New England Highway bypass of Singleton

Addendum review of environmental
factors

August 2024

Figure 6-6: Proposed modification – one per cent AEP peak flood level impact (Source: Aurecon, 2024a)

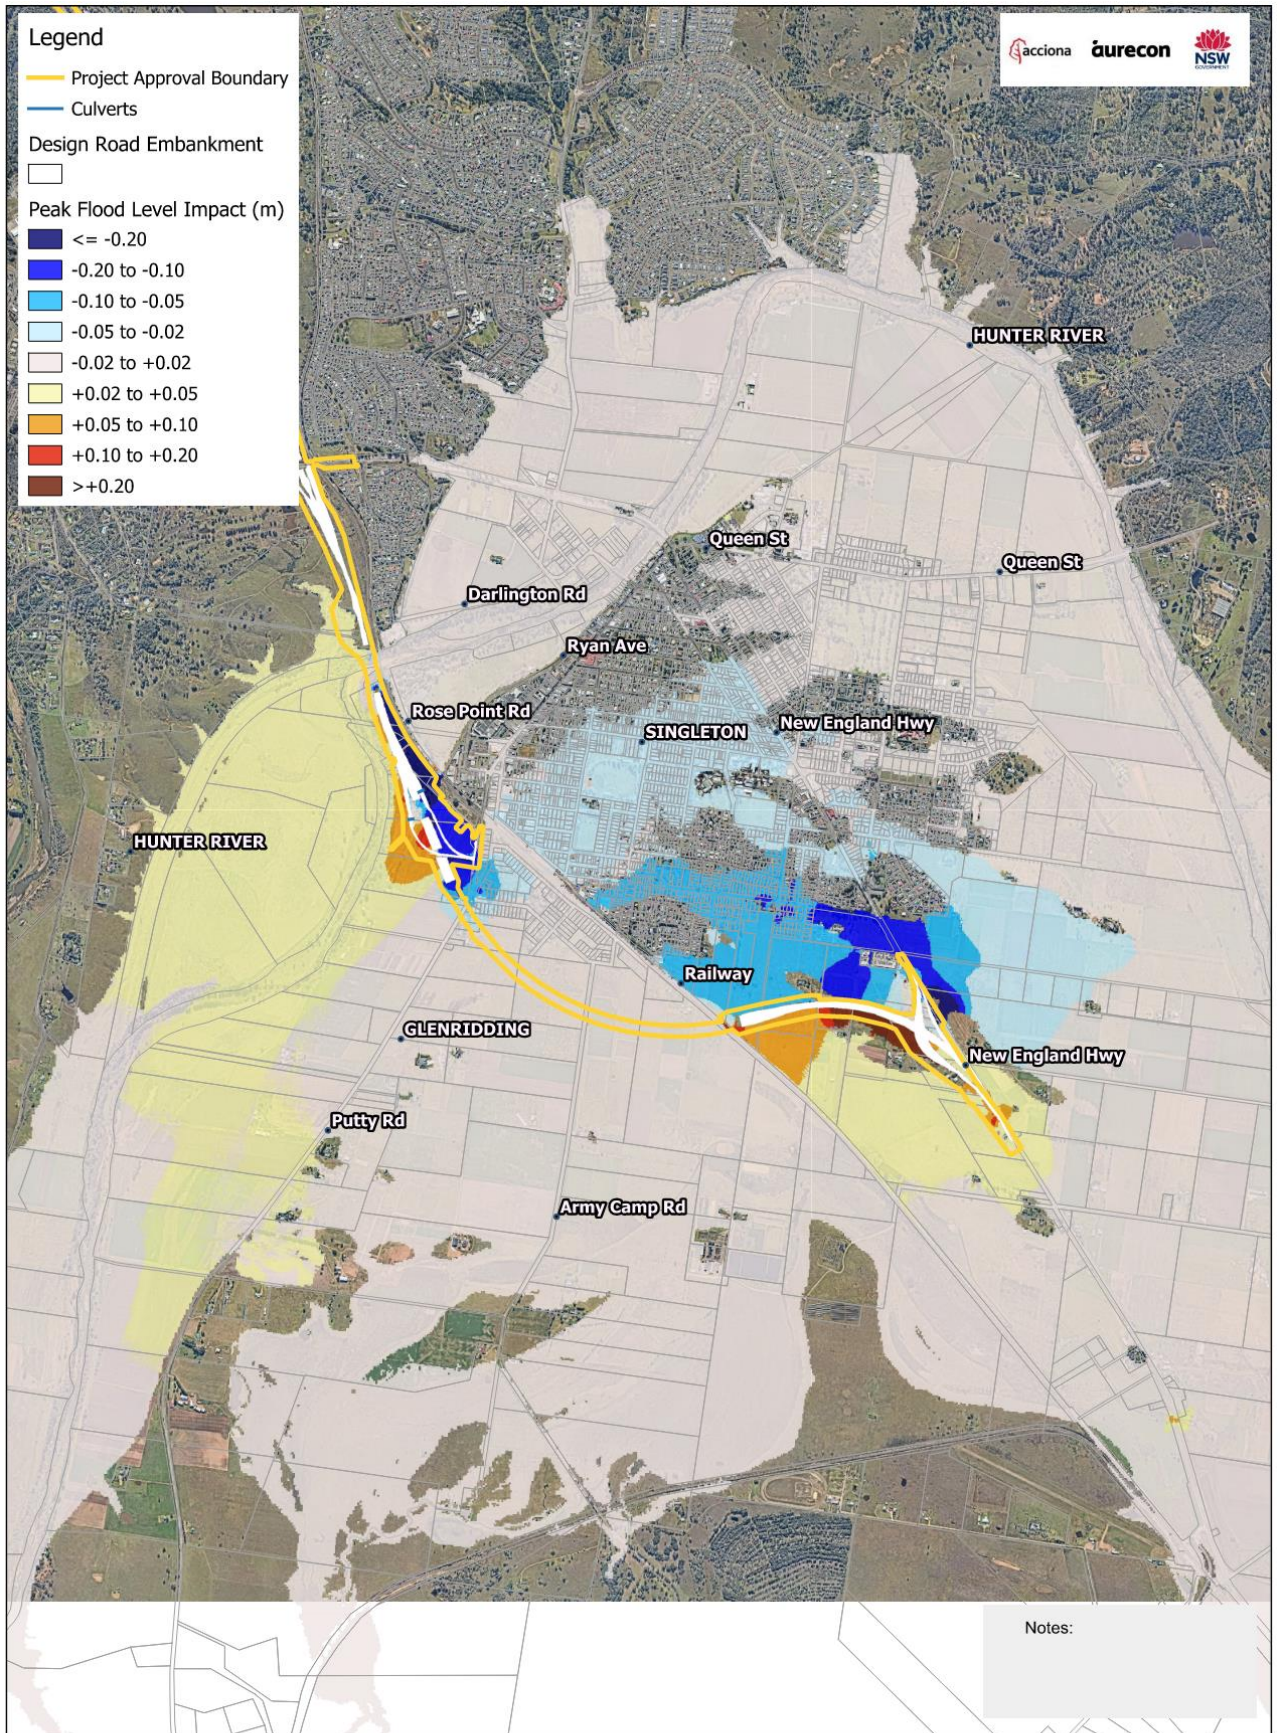
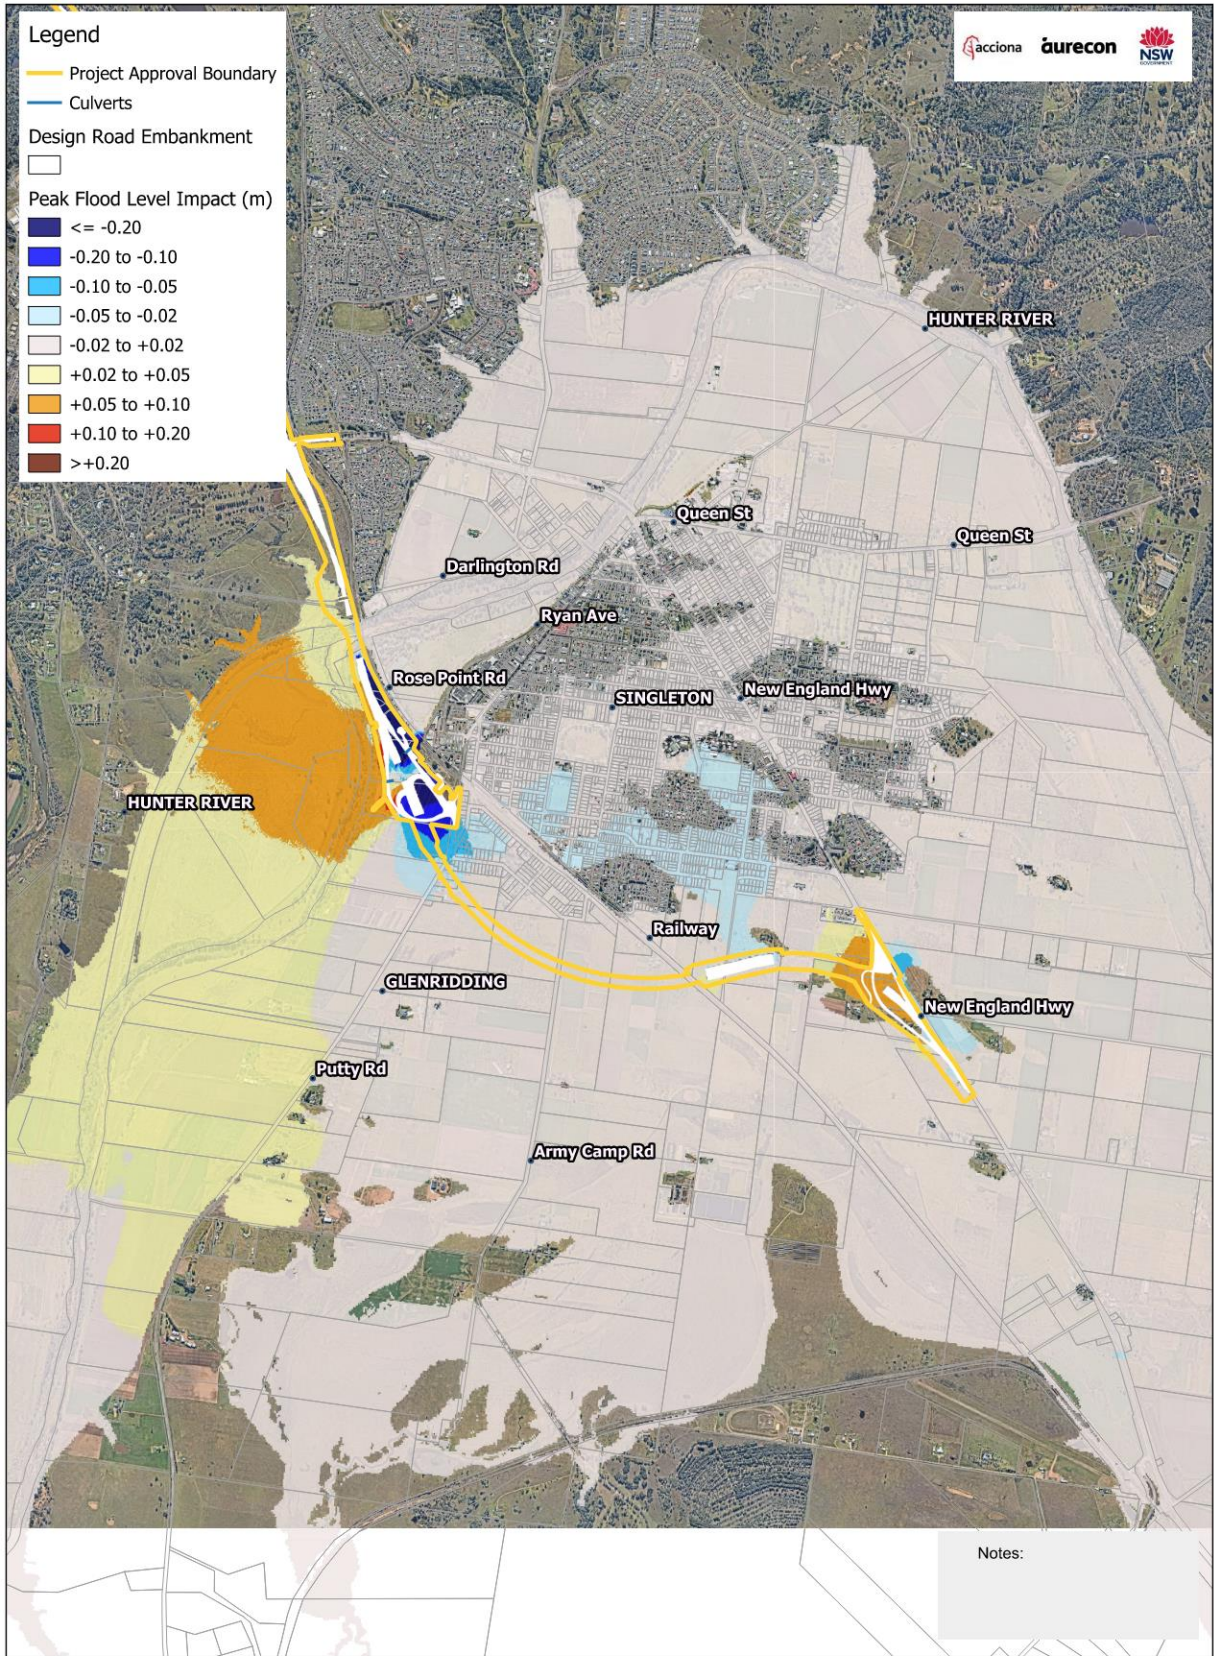
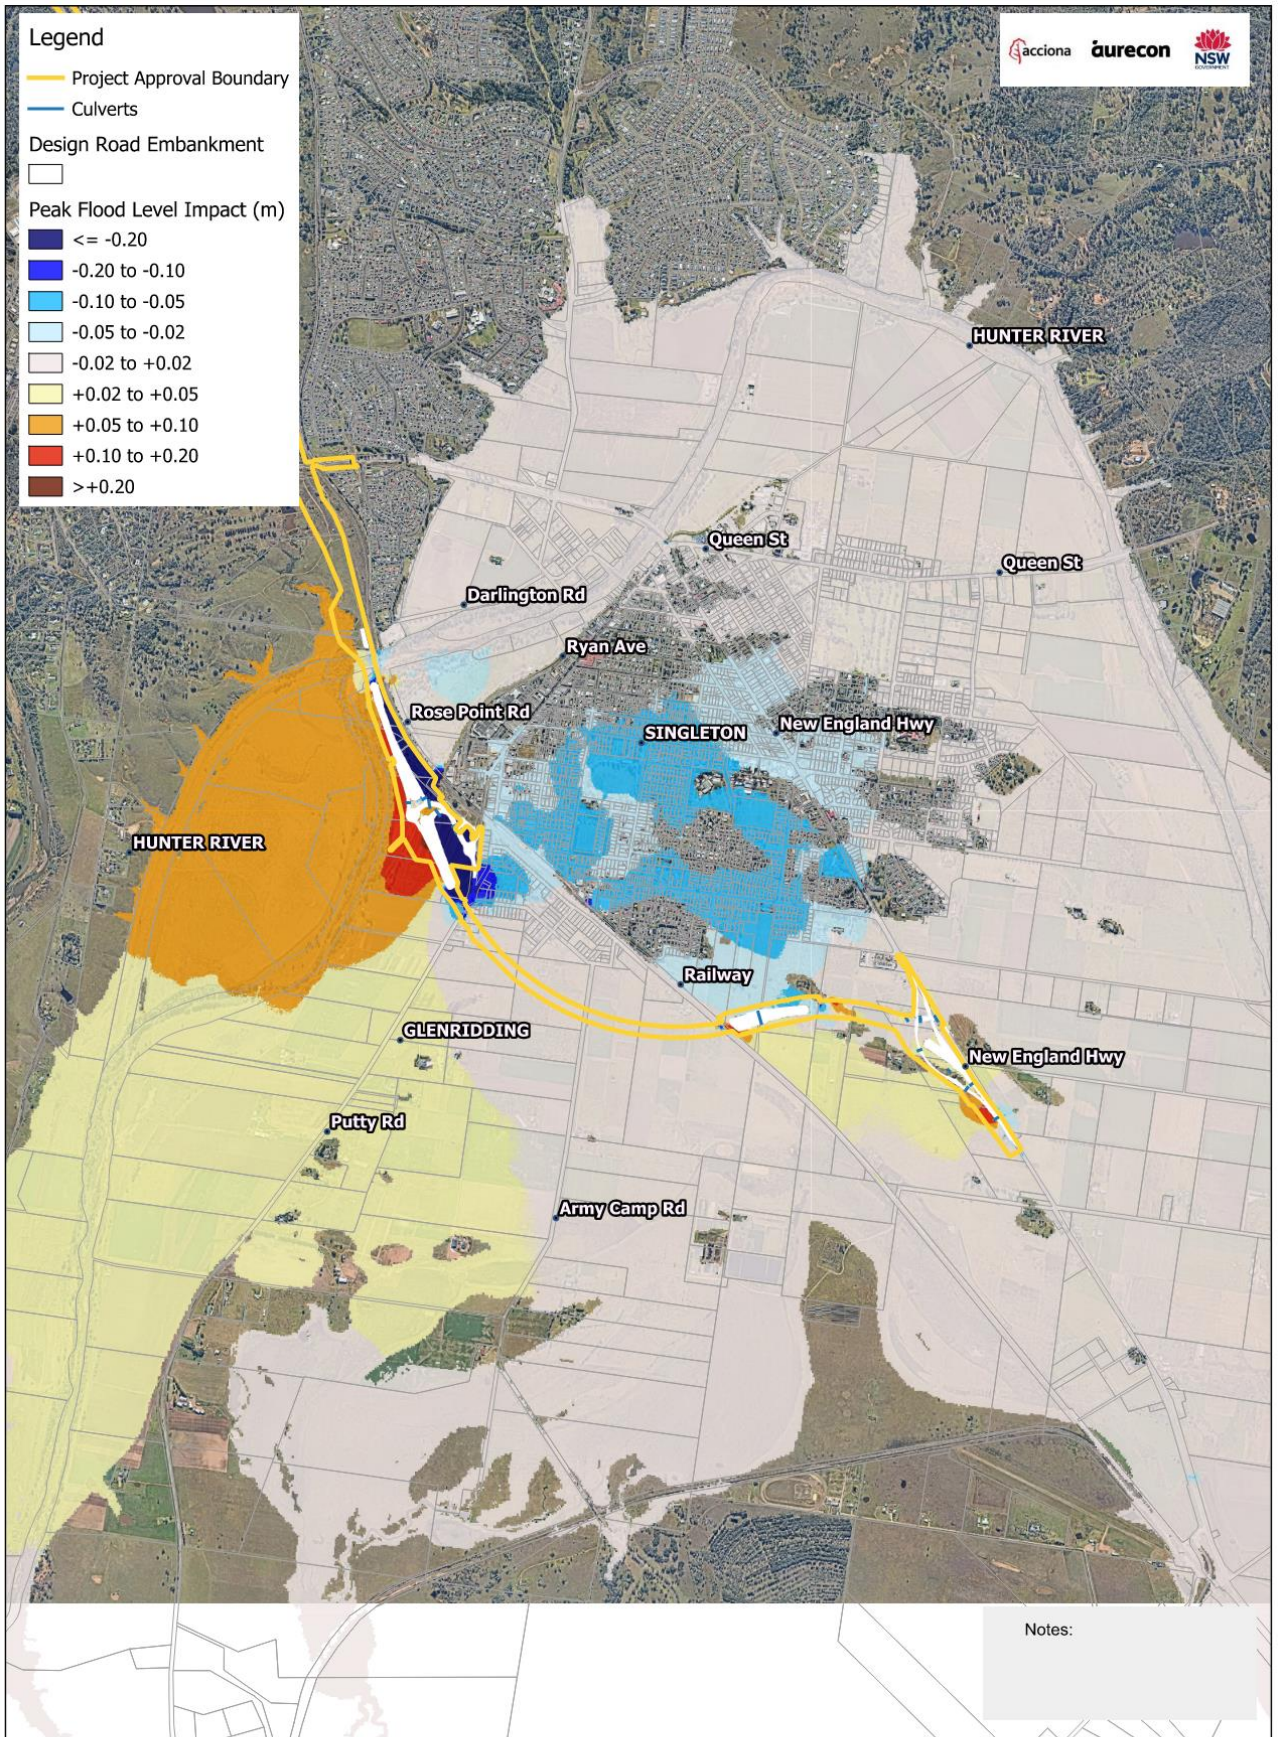
Flood event	Summary of changes resulting from the proposed modification compared to the approved project (as presented in the addendum REF (October 2023))	Summary of changes resulting from the proposed modification compared to the project REF (December 2019)
	<p>properties in Glenridding (when compared to existing conditions) and are associated with the redistribution of flow due to the Putty Road connection and the northern abutment of the bridge over the Doughboy Hollow floodplain.</p> <p>At the southern connection, there are increases in the range of 0.03 metres to 0.06 metres. The impacts are limited to rural properties. Impacts at existing residential dwellings do not result in new above floor flooding.</p>	<p>of flow due to the Putty Road connection and the northern abutment of the bridge over the Doughboy Hollow floodplain.</p> <p>At the southern connection, there are increases in the range of 0.04 metres to 0.06 metres. The impacts are limited to rural properties.</p>

1% AEP	<p>This event shows the largest change resulting from the proposed modification when compared to the approved project. This is illustrated in Figure 6-5 and Figure 6-6.</p> <p>At the one per cent AEP event the flood impacts near the Putty Road connection and the southern connection generally increase in extent and magnitude. Much of the land local to the connections has been acquired by Transport for the construction and operation of the Singleton bypass. Therefore, depending on the extent of land acquisition, the largest localised impact may not result in any adverse effects to private property.</p> <p>On the Hunter River upstream of the Singleton bypass, the increase in peak water level is typically 0.03 metres compared to the approved project. Localised increases of between 0.08 metres and 0.25 metres occur immediately upstream of the Putty Road connection. Increases of up to 0.02 metres are observed across the Doughboy Hollow floodplain. The impacts are limited to rural properties. Impacts at existing residential dwellings do not result in new above floor flooding.</p> <p>There is an overall reduction in peak flood level to urban areas of Singleton due to the proposed modification. The magnitude of the reduction has increased to -0.05 metres compared with -0.02 metres for the approved project.</p>	<p>The change resulting from the proposed modification, when compared to the project REF, is illustrated in Figure 6-4 and Figure 6-6.</p> <p>At the one per cent AEP event the flood impacts near the Putty Road connection and the southern connection generally increase in extent and magnitude.</p> <p>On the Hunter River upstream of the Singleton bypass, the increase in peak water level is typically 0.04 metres. Localised increases of up to 0.08 metres occur immediately upstream of Putty Road connection. Increases of up to 0.02 metres are observed across the Doughboy Hollow floodplain. There would be an overall reduction in peak flood level to urban areas of Singleton due to the proposed modification. The magnitude of the reduction has increased to -0.05 metres compared with -0.03 metres for the project REF.</p> <p>At the southern connection, there are increases of up to 0.15 metres. This increase is primarily due to the inclusion of the bridge over the bypass at the southern connection, compared with an embankment in the project REF. This now allows flow through to this area of the southern connection. The impacts are limited to rural properties. Impacts at existing residential dwellings do not result in new above floor flooding.</p>
